**ADDENDUM NO. 1
TO THE
BIDDING REQUIREMENTS AND CONTRACT DOCUMENTS
FOR THE
DIV IV DRY WEATHER PUMP STATION AND FORCE MAIN REHABILITATION**

OWNER: City of Anderson

ISSUED BY/ENGINEER: Egis Group
8320 Craig Street
Indianapolis, Indiana 46250

ISSUE DATE: July 1, 2025

PLAN DATE:	6/26/2025
DESIGN:	PRW
CHECK:	BAB
DRAWN:	DCW
PROJECT NO.	120046
SHEET NO.	C107

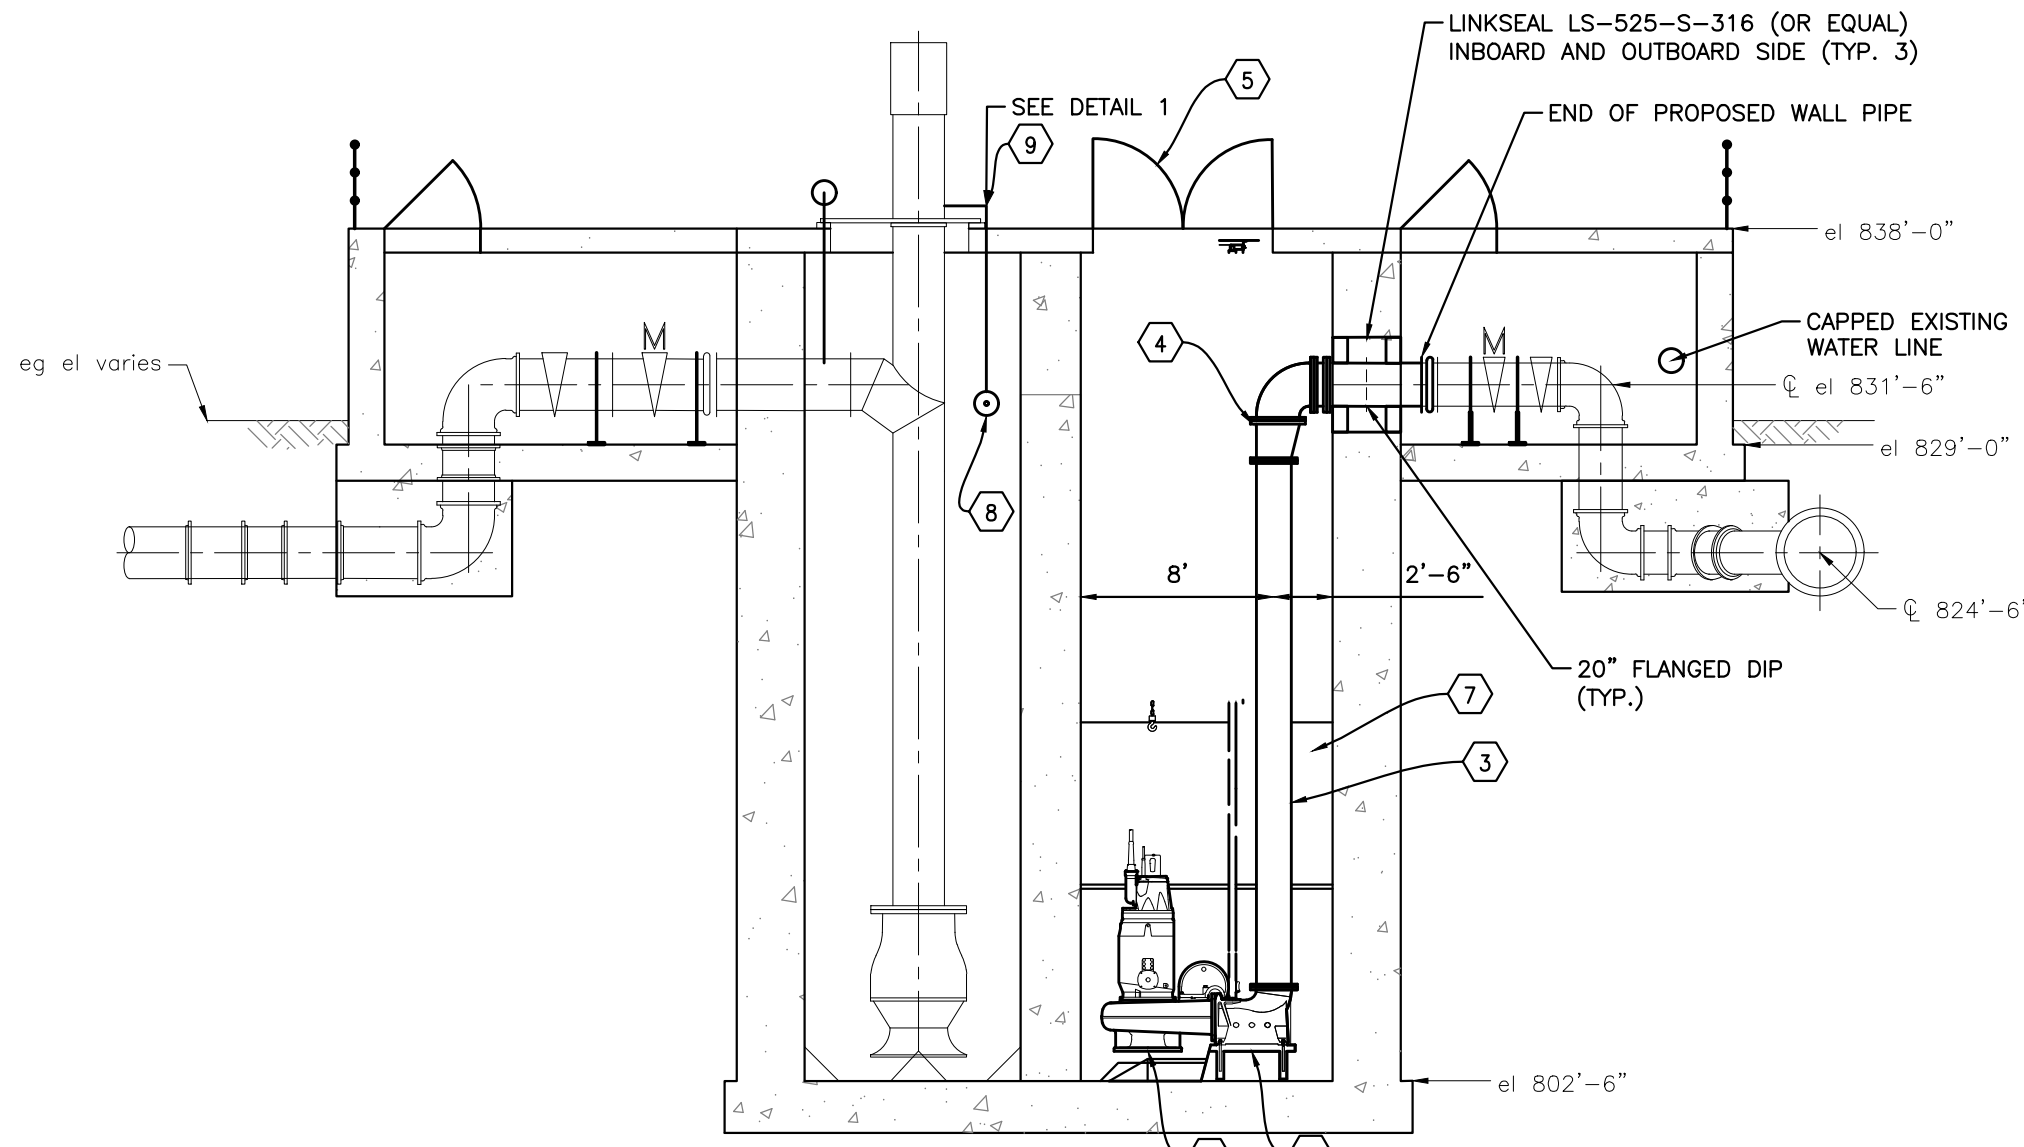
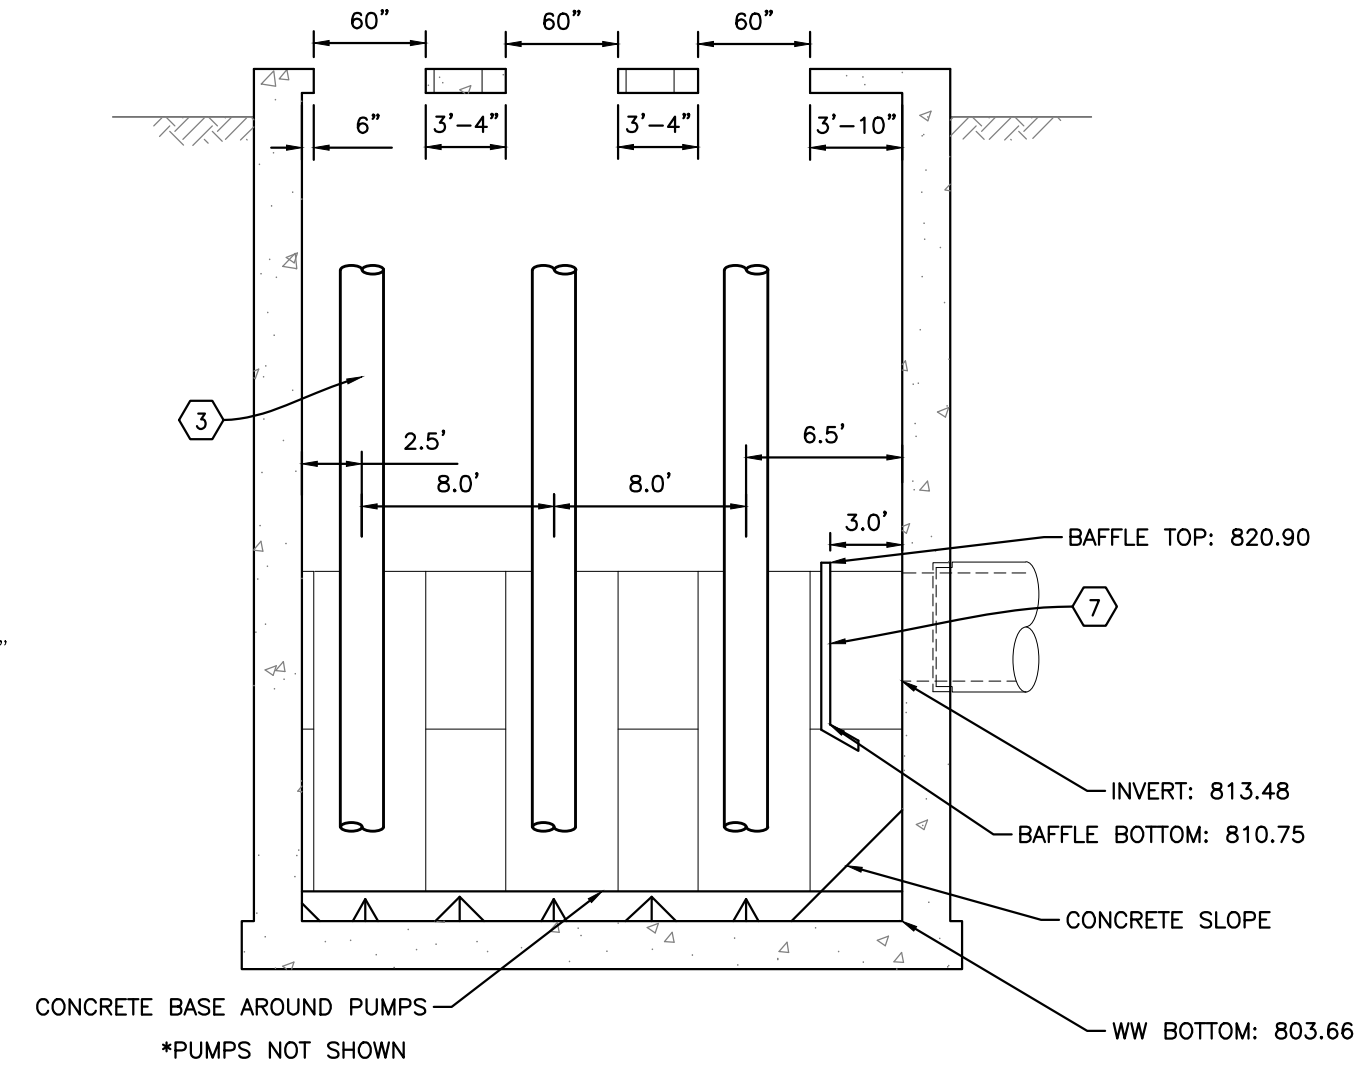
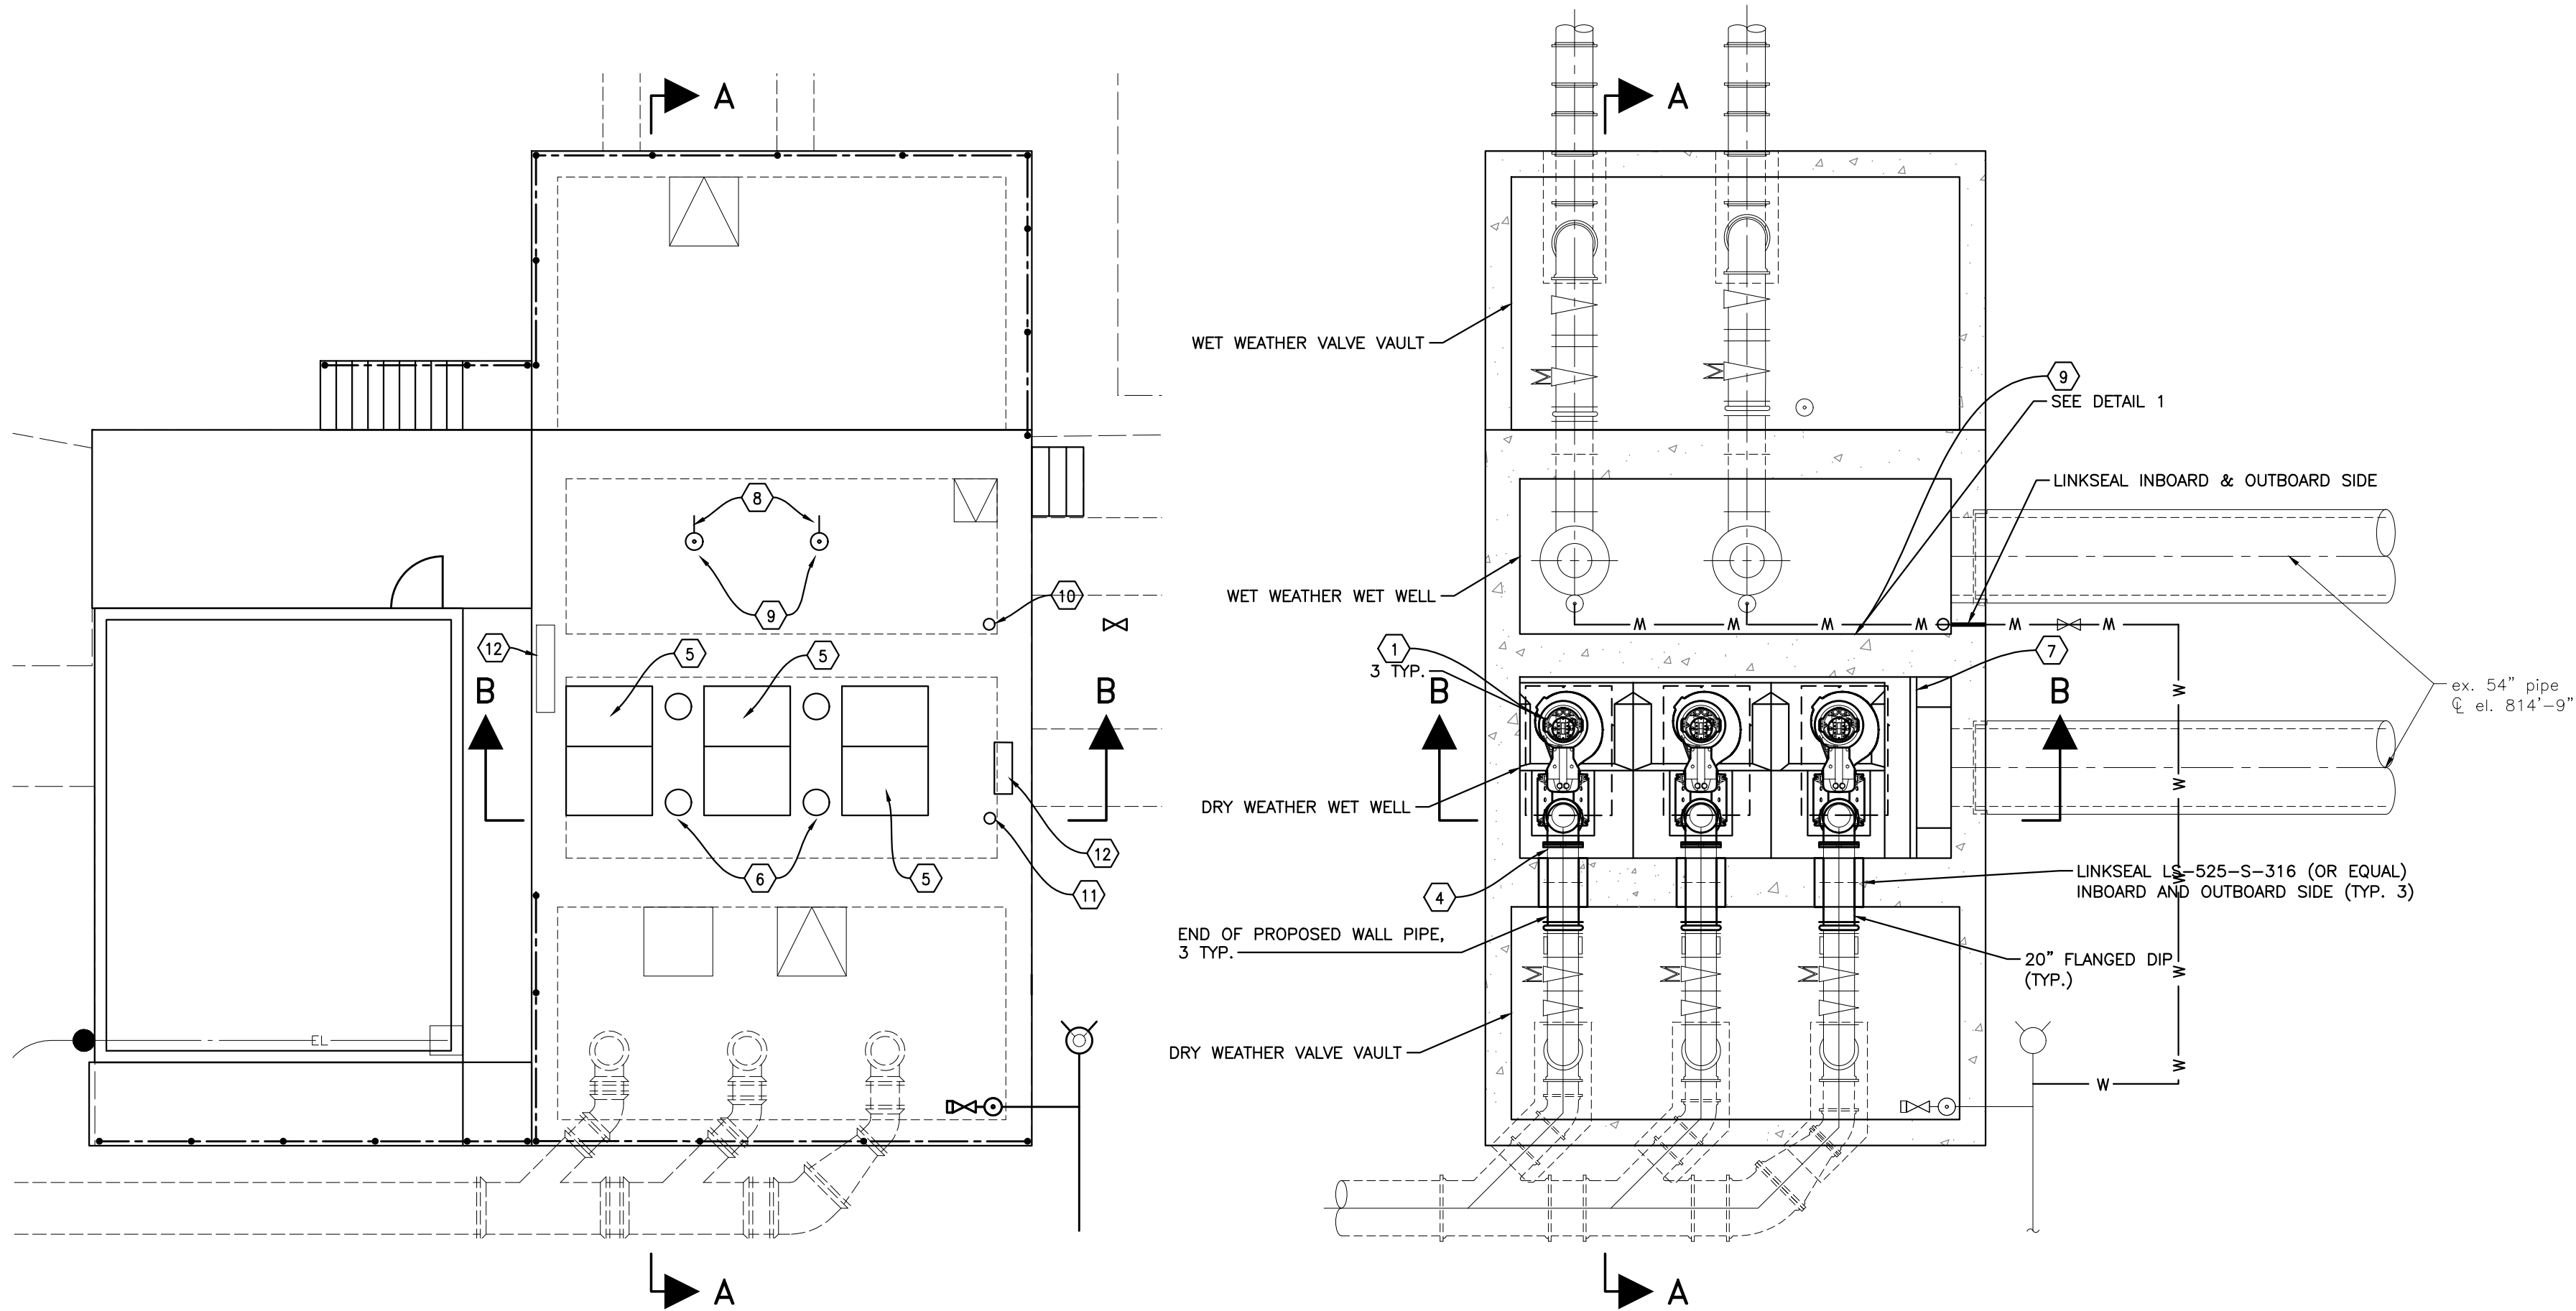
A. Sheet C107 – The last sentence of Note 5 should read:

- 4 NEW ECCENTRIC 20"x16" DIP REDUCER WITH 20" DIP ELBOW AND 20" TO CONNECT TO EXISTING FLANGE IN VALVE VAULT.
- 5 PROVIDE NEW 90"x60" OUTSIDE DIMENSION HATCH WITH A CLEAR OPENING OF NO LESS THAN 80"x53". HATCHES ~~SHOULD HAVE~~ DOUBLE DOORS, HINGED ON THE 60" AND BE EQUIPPED WITH SAFETY GRATES. SEE SPECIFICATION ~~07721~~ **07721** FOR ADDITIONAL INFORMATION.

See Specification 07721 - Hatches for additional information.
